Consultant	Wahib Medanat Consultant Engineer	Rep No.	12-16082021
Contractor	Derar Saraireh & Sons for Engineering & Contracting	Tender No.	(11/2019/USAID/SKEP/3/S) Schools for a Knowledge Economy Project (SKEP) - Phase (3) Package (1, 2)
Site Name	Al Khansa' Basic Mixed School- Al Balqa	Day/ Date	Mon. 16/08/2021
Duration of Project	450 Calendar Days	Total Project Budget	9,789,417.840 JD

Visit Notes

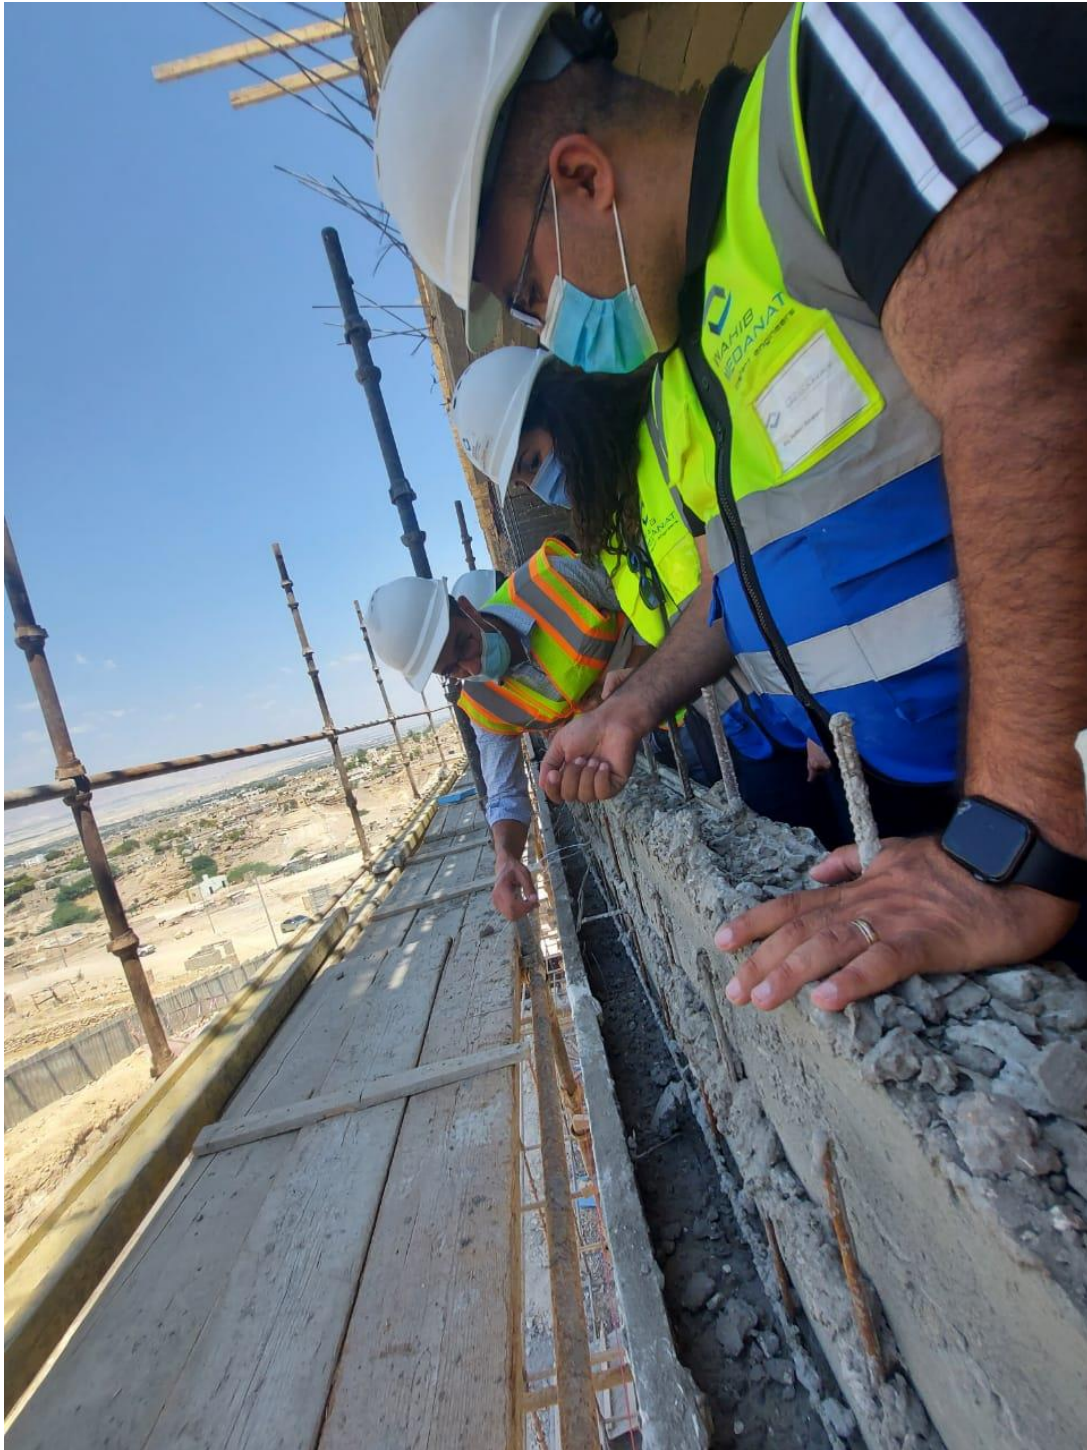
The built stone courses-zone "A" have been inspected and show that the work in general is acceptable

except limited area where the Contractor was requested to remove and replace two courses using the right method in building including the use of metal accessories
